P.O.A.D.P. PLAN

WOODLAKE COMMERCIAL

Re: Woodlake Commercial

P.O.A.D.P REVIEW

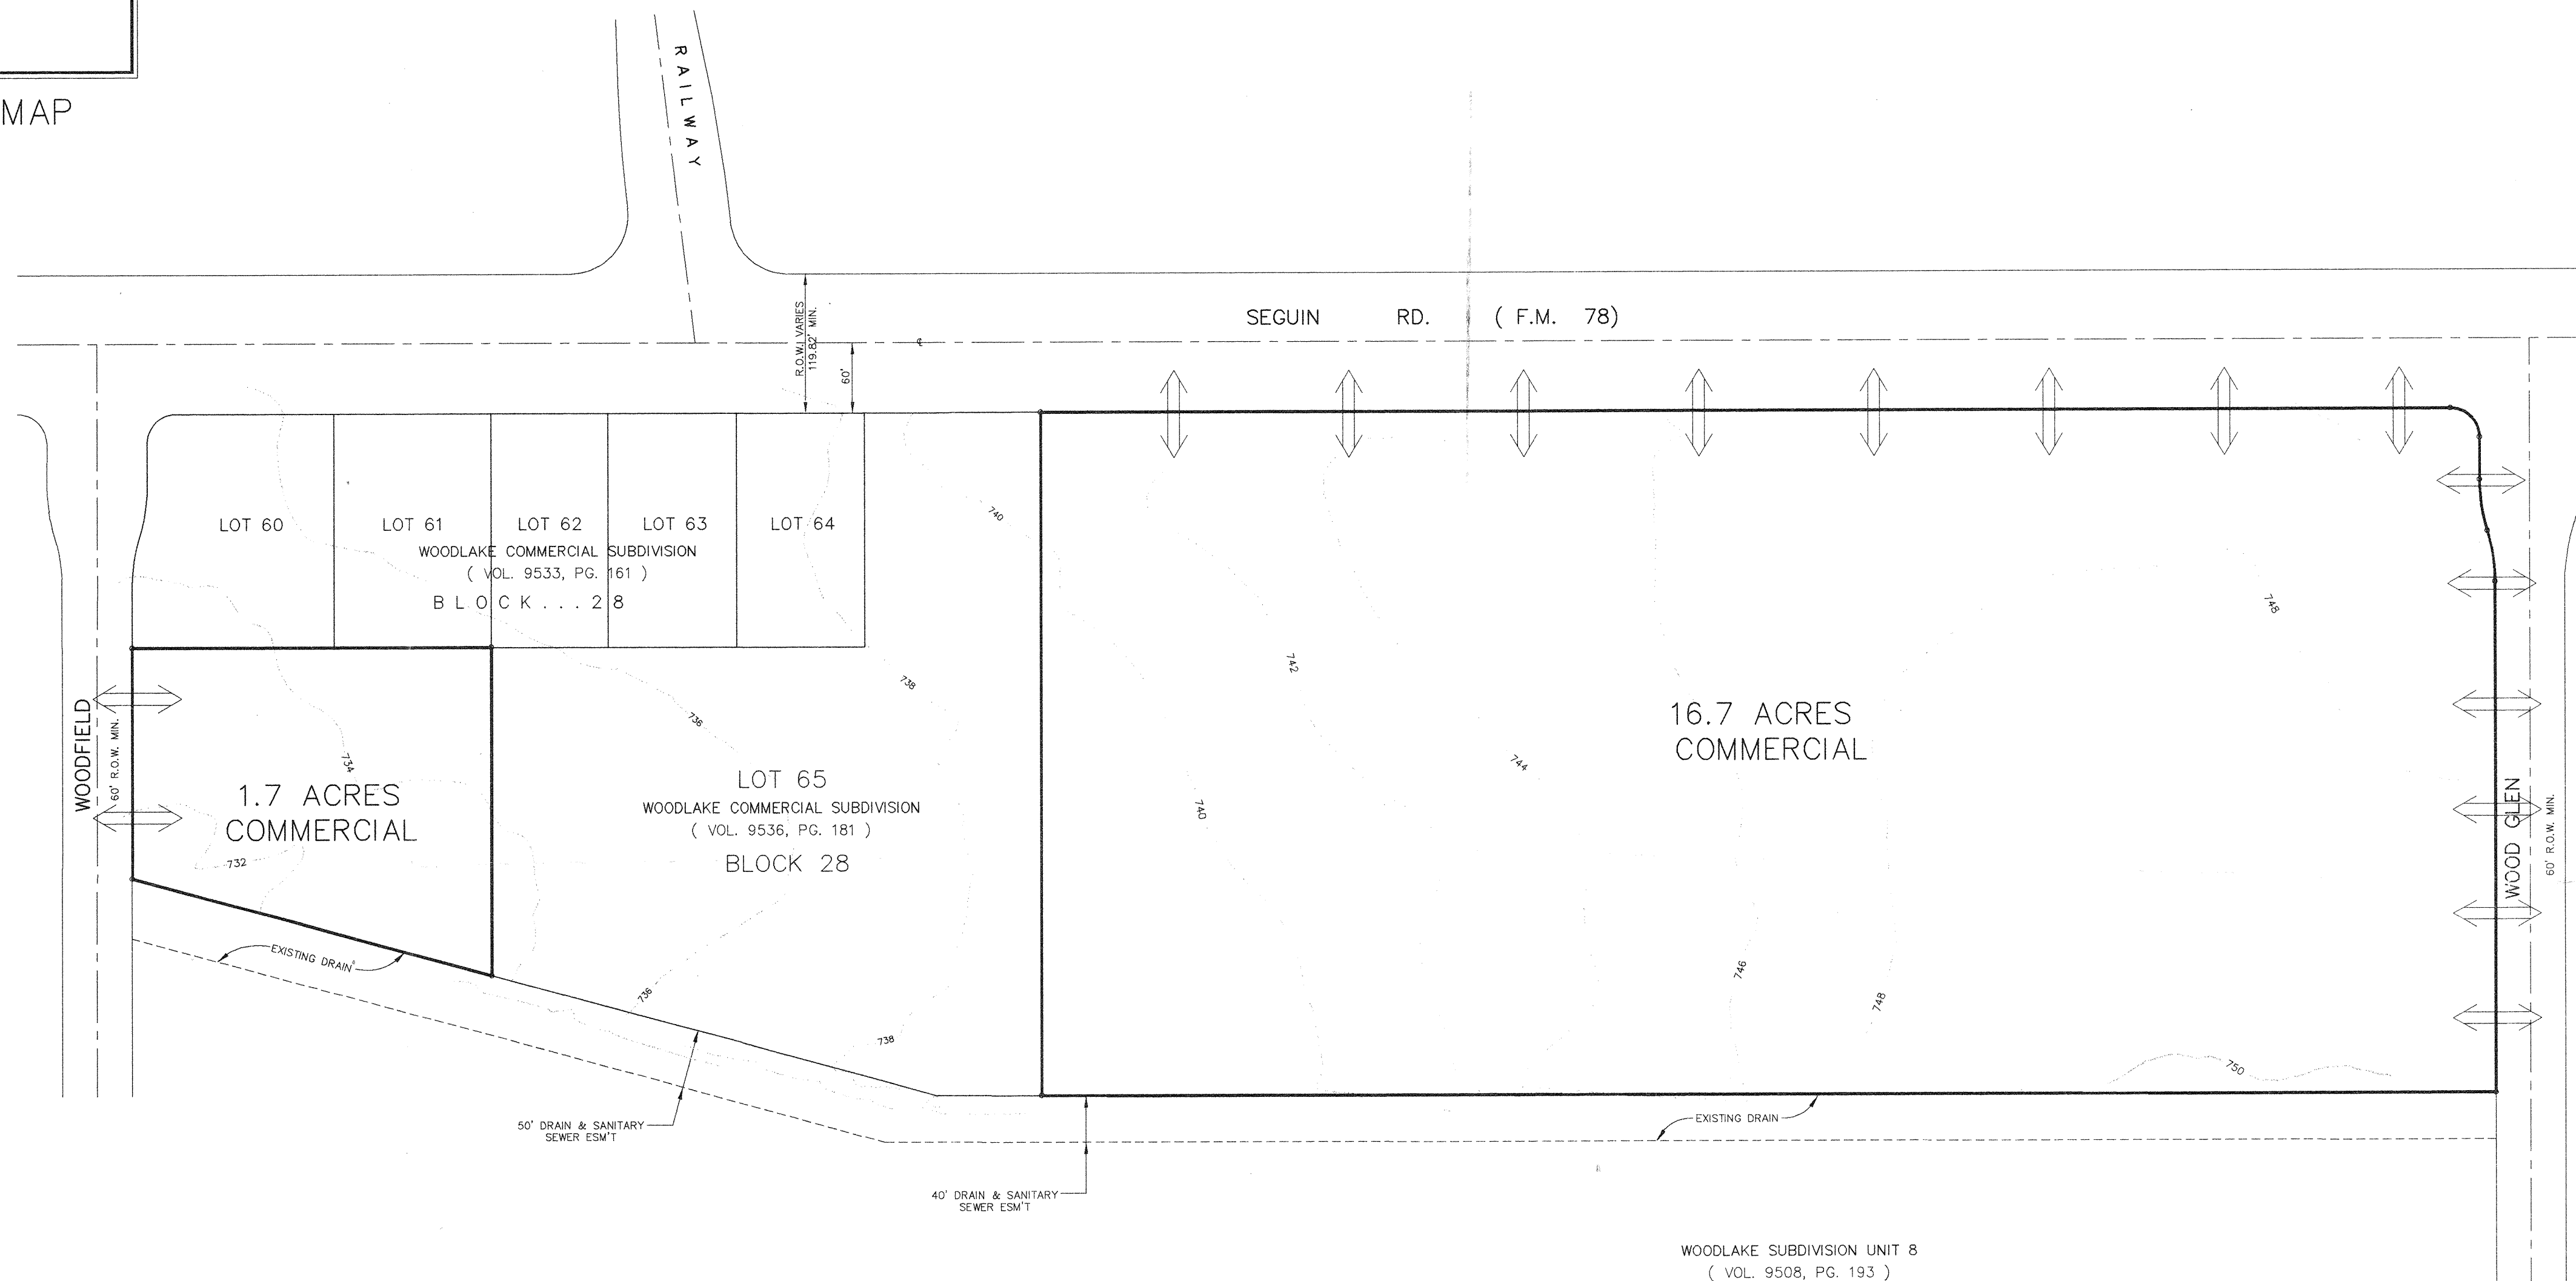
- Based on the topography, a Flood Plain Study and drainage review will probably be required during the platting process.
- Access and R.O.W. issues along State facilities will need to be resolved with the Texas Department of Transportation (TXDOT). For information about these requirements you can contact TXDOT at 615-5814.
- This development will need to comply with tree preservation ordinance #85262. For information about these requirements you can contact Building Inspections at 207-7102.
- It will be expected that you will plat all of the property depicted in your POADP, to include: floodpains, drainage areas and open space.
- I would encourage you to work closely with the school district, so that they can plan accordingly.

For residential development directly adjacent to State ROW, the developer shall be responsible for adequate set-back and/or sound abatement.

50' ROW flares will be required at the intersection of Wood Glen and FM 78.

This property is eligible for a maximum combined total of six(6) access points, based on the overall combined FM 78 frontage. Locations of access points will be as directed by "Regulations For Access Driveways to State Highways".

Drainage easements maybe require and
will be address during the platting process

Proposed to consist of a neighborhood shopping center, this property is estimated to generate 971 peak hour trips based on the ITE Trip Generation Manual. With the intent of shared driveways and common access, these trips will be distributed through two driveways on 600 ft frontage of Woodglen, two driveways on 800 ft frontage F.M. 78, and one driveway on 210 ft frontage Woodfield.
